City of Cocoa

Planning and Zoning / Local Planning Agency

[21-118](#) Approval of a BINDING DEVELOPMENT AGREEMENT / Final PLANNED UNIT DEVELOPMENT (PUD) REZONING / PRELIMINARY SUBDIVISION / LARGE SCALE SITE PLAN consistent with Chapter 18 Subdivisions and Appendix A Zoning of the City Code for the Cirrus Mixed-Use PUD project.

PLANNING & ZONING BOARD/LOCAL PLANNING AGENCY AGENDA ITEM

OVERALL PAVING,
GRADING, AND
DRAINAGE PLAN

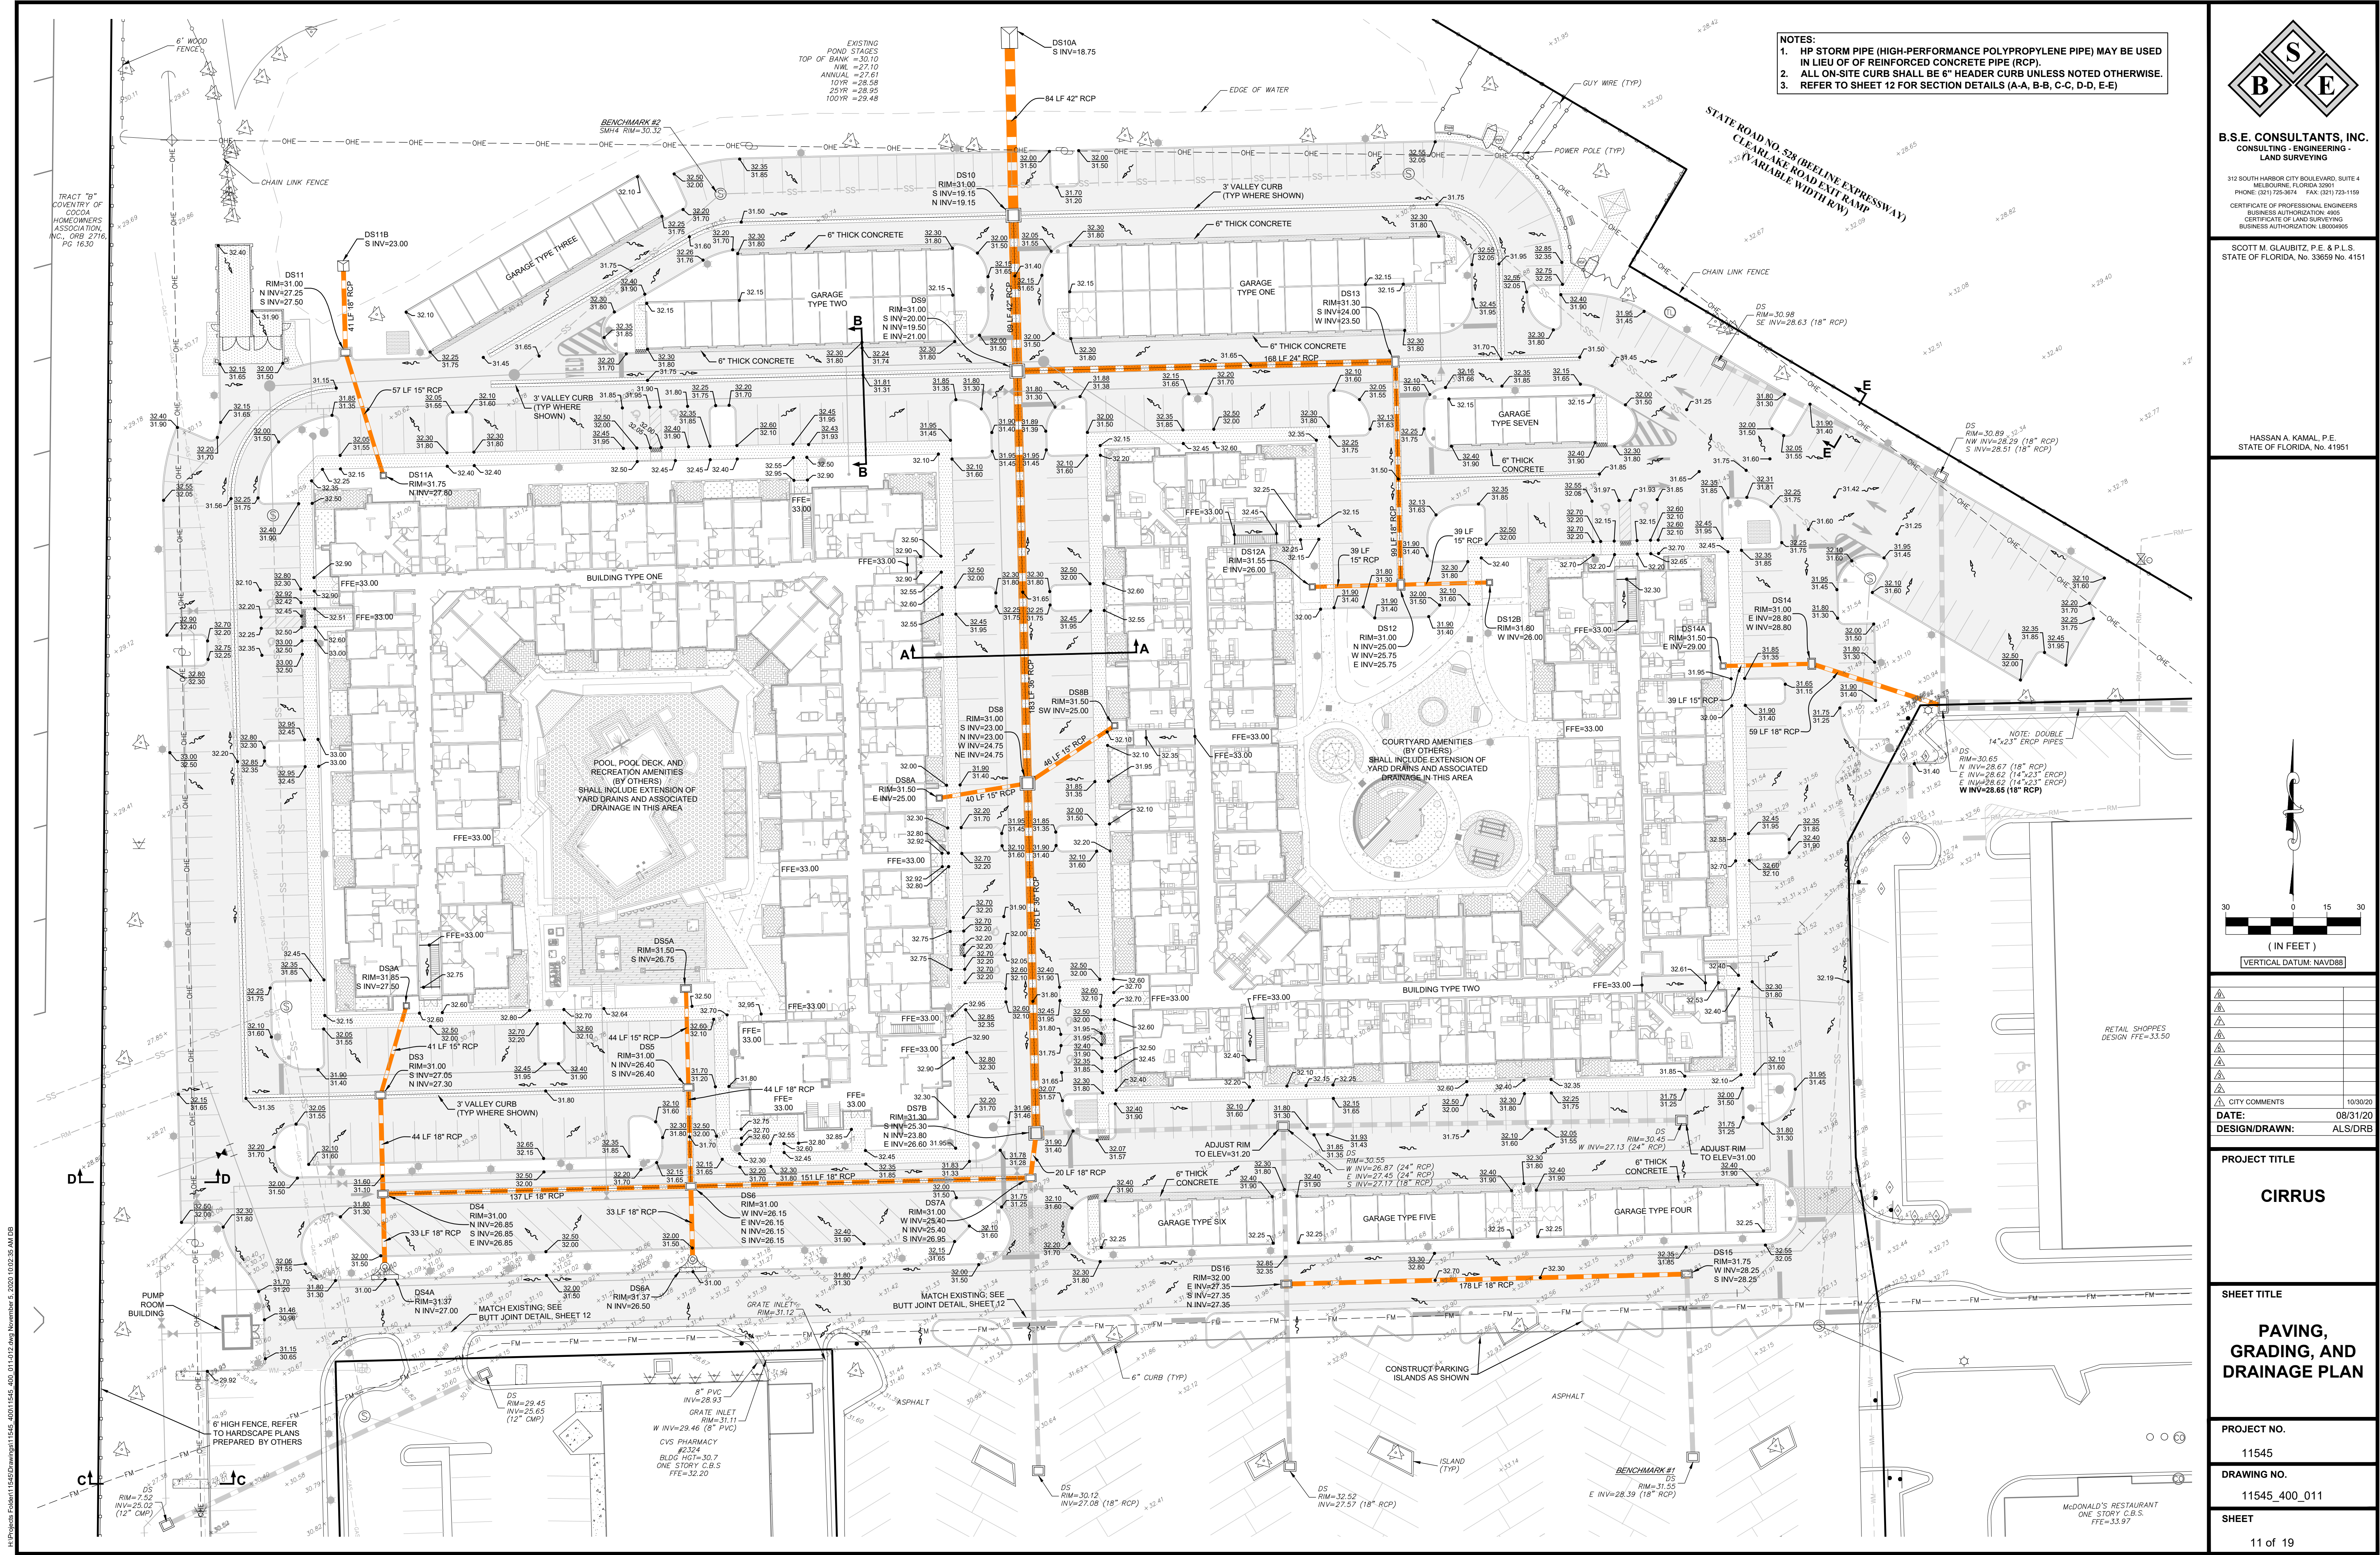
- a. Sheet 10-Comment #7-The intent of this comment is to provide protection to the neighborhood to the west. The area proposed to be raised is outside of the delineated wetland area. Please provide follow-up related to this comment after discussions with SJRWMD. Ideally, 1-ft of freeboard should be provided between the rim of the control structure and all pond banks. No less than 0.5' should be provided.

- b. Sheet 10 - Comment #10 -This is acceptable. From a future maintenance standpoint, the concern is that an 8" pipe clogs very easily.
- c. Sheet 10 - Comment #12 -Sidewalk to SR-524. 0.3 miles is not a-significant walk and only takes 7-10 minutes. A sidewalk here would prevent Cirrus residents from navigating through the parking lot to get to an existing signalized intersection with crosswalks in place. Future development in the Cocoa Commons area will require sidewalk connectivity as well. Please provide a sidewalk along the west entry from the project site to SR-524.

- d. Sheet 10-Comment 13-The rim is still shown higher than the west TOB of the drainage swale. The rim is shown as 30.21. Section C-C shows a TOB of 30.0. Please provide grading to ensure the TOB is higher than the rim. 1.0' of freeboard is ideal, but 0.5' should be the minimum space between the rim and TOB.

- e. Sheet 10 - Comment #14 -This is the main outfall for this pond. If blocked it could cause flooding to the subject site and west properties. Confirm with FDOT, but their
